UPGRADE OF 30-182 BRAKE ASSEMBLY TO 30-182A CONFIGURATION

This service bulletin is applicable to all Parker Hannifin Corporation, Aircraft Wheel & Brake Division part number 30-182 brake assemblies.

Figure 1 Lining comparison

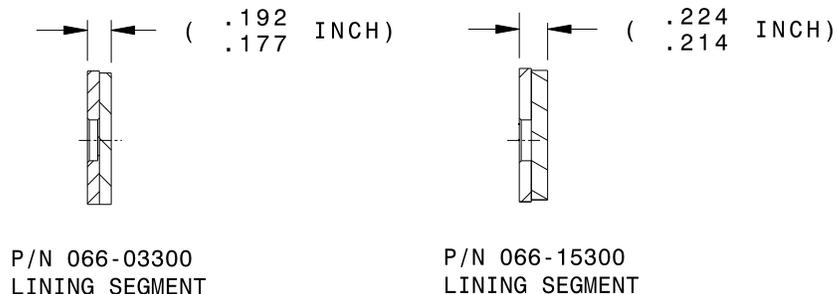
Lining P/N 066-03300 used in the P/N 30-182 brake assembly is superseded by P/N 066-15300 used in the P/N 30-182A brake assembly. This document provides the necessary instructions to upgrade the 30-182 brake assembly to the 30-182A configuration.

CAUTION: LININGS MUST BE REPLACED IN COMPLETE SETS ON EACH BRAKE ASSEMBLY. THE 066-15300 LINING IS 0.035 INCH THICKER THAN THE 066-03300 LINING.

Figure 2 Remove the 4X back plate assembly

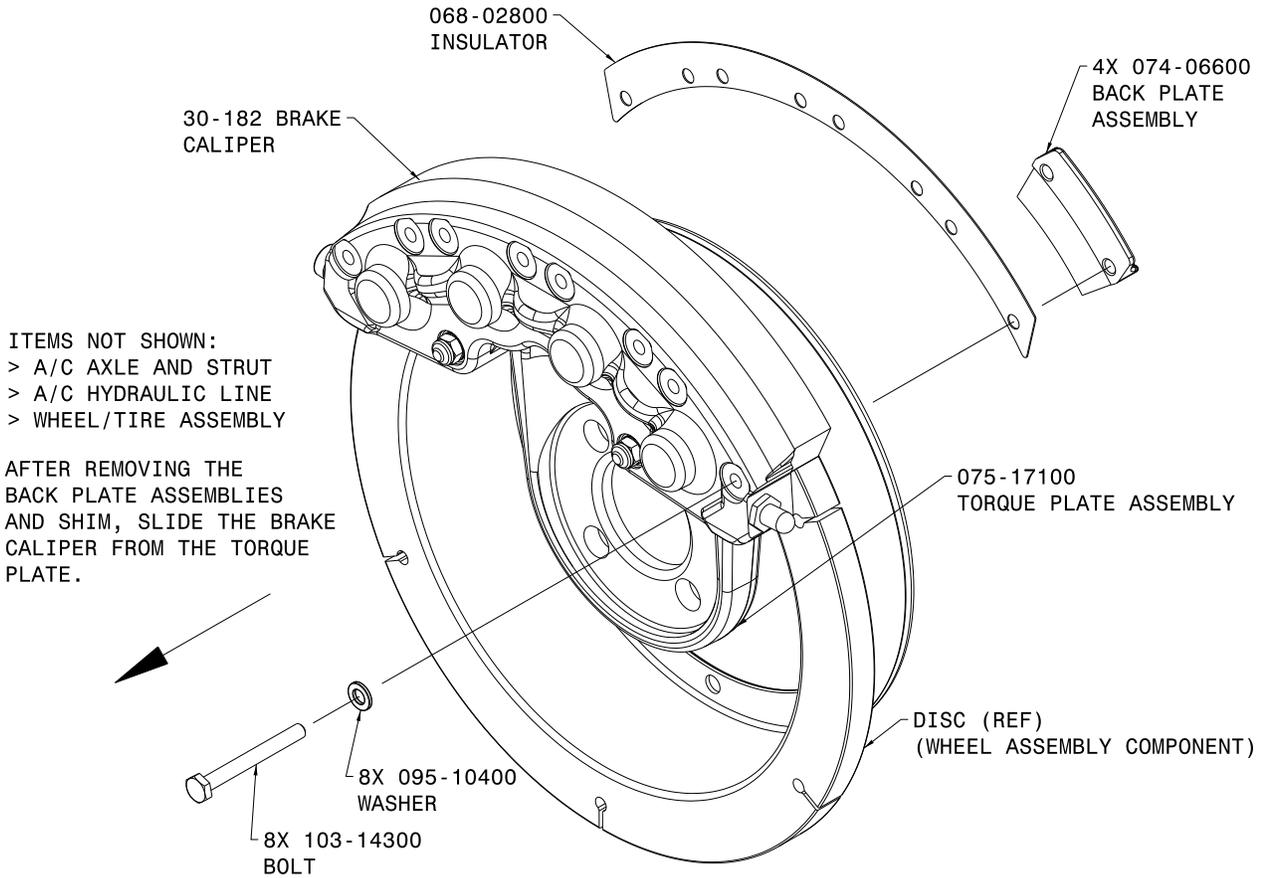
- (1) Refer to Figure 2. Remove and retain the existing 4X back plate assemblies (074-06600) by loosening and removing the 8X bolts (103-14300) and washers (095-10400). Remove and retain the shim (068-02800).

Figure 3 Remove the pressure plate assembly

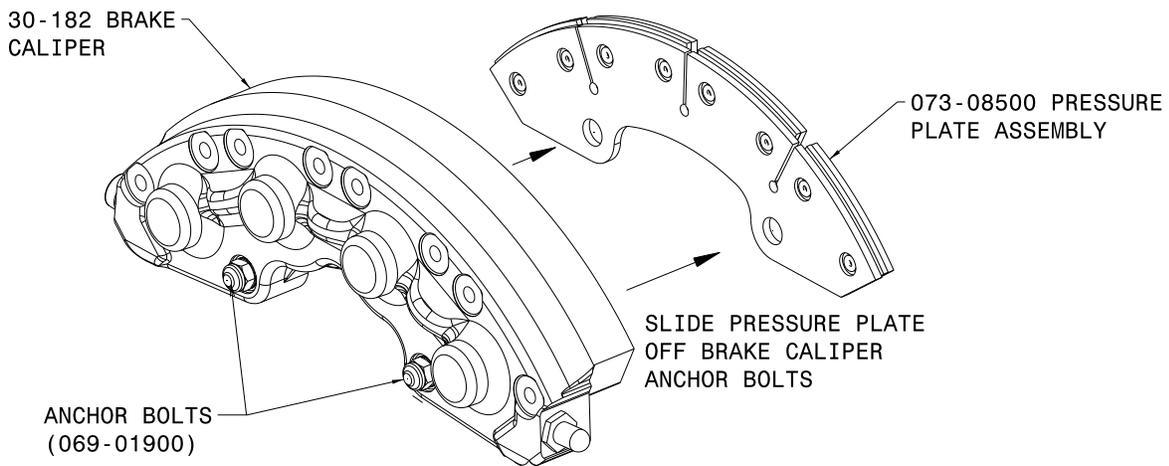
- (2) Refer to Figure 3. Slide the brake caliper free from the torque plate and remove and retain the existing pressure plate assembly (073-08500) by sliding over the anchor bolts which are press fit into the brake housing.
- (3) Temporarily support and secure the brake so that it will not cause binding of the aircraft hydraulic line.

Figure 4 Remove the attachment pins

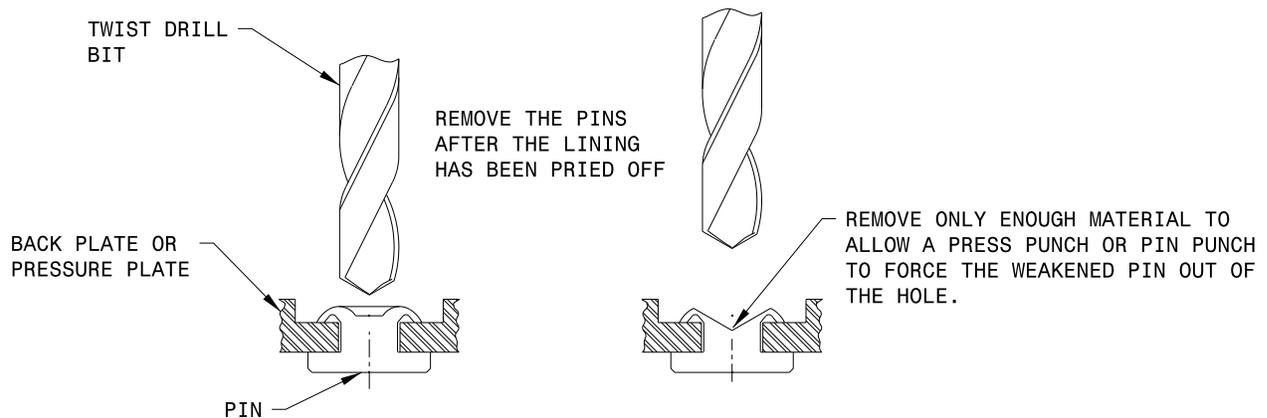
- (a) Refer to Figure 4. Use a twist drill bit and carefully drill into the clinched end of the pin. Remove only enough material to allow a press punch or pin punch to force the pin out of the hole without deforming or enlarging the hole. Discard the pin.

Figure 5 Install the attachment pins

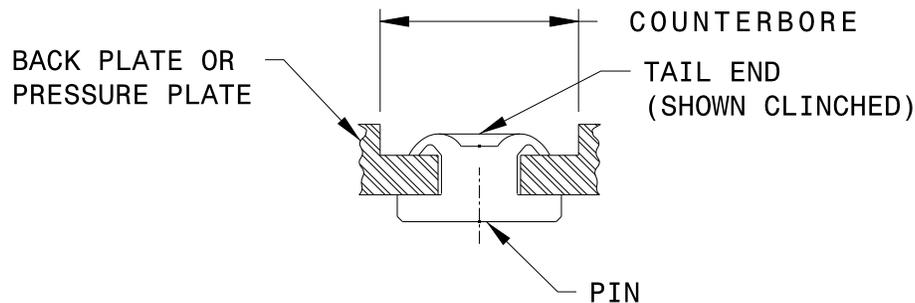
- (4) Install new pins (177-00300). Refer to Figure 5.
- (a) If replacing damaged attachment pins, install new pins in each back plate and pressure plate as follows:
- 1 Install with the tail end of the pin (end to be clinched) toward the counterbore side of the back plate or pressure plate.
 - 2 Place pins and back plate or pressure plate on a flat metal surface.
 - 3 Using appropriate rivet tools, install the pins.

Figure 6 Pin installation acceptance criteria

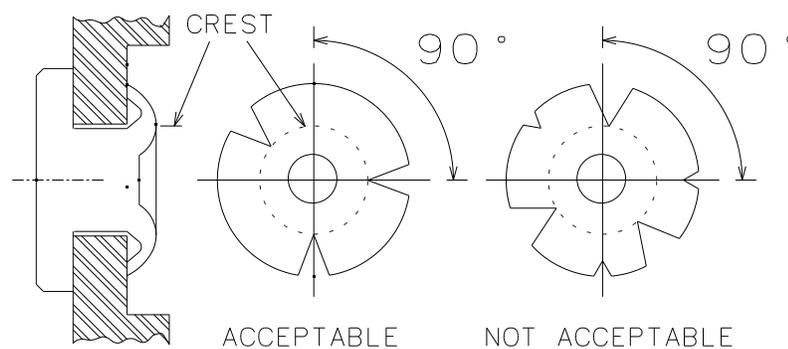
- (b) Check to make sure that the attachment pins are tight and movement free with no distortion of parts. Refer to Figure 6 for pin installation acceptance criteria.
- 1 The split shall not occur inside the crest of the clenched surface.
 - 2 No more than two splits shall occur in a 90° area.
 - 3 A total of no more than three splits shall be allowed.

Figure 7 Attach the new lining segments (066-15300)

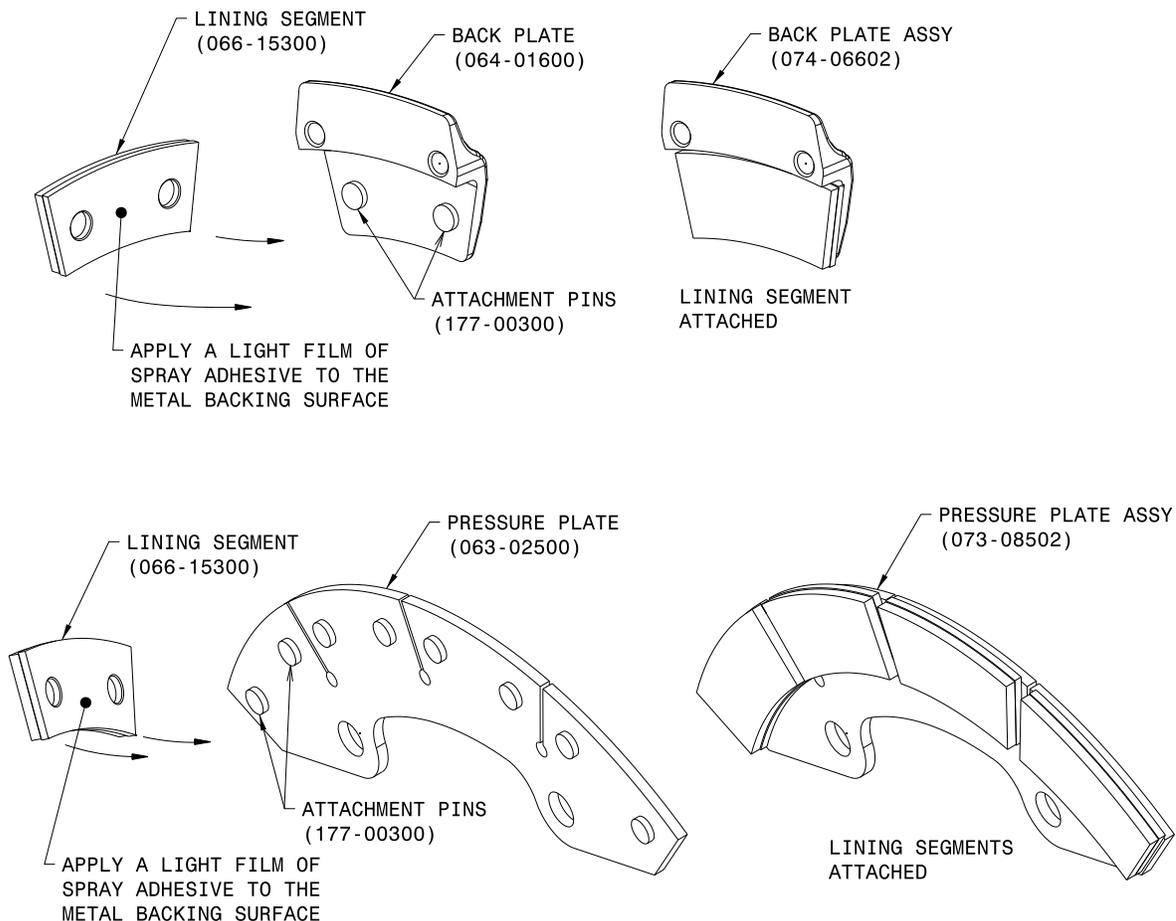
- (5) Install the new lining segments (066-15300). Refer to Figure 7.

- (a) Apply a light film of spray adhesive to the metal backing of the lining segment and install the lining segment onto the pins. Check to insure that the metal backing is tight against the back plates and the pressure plate.
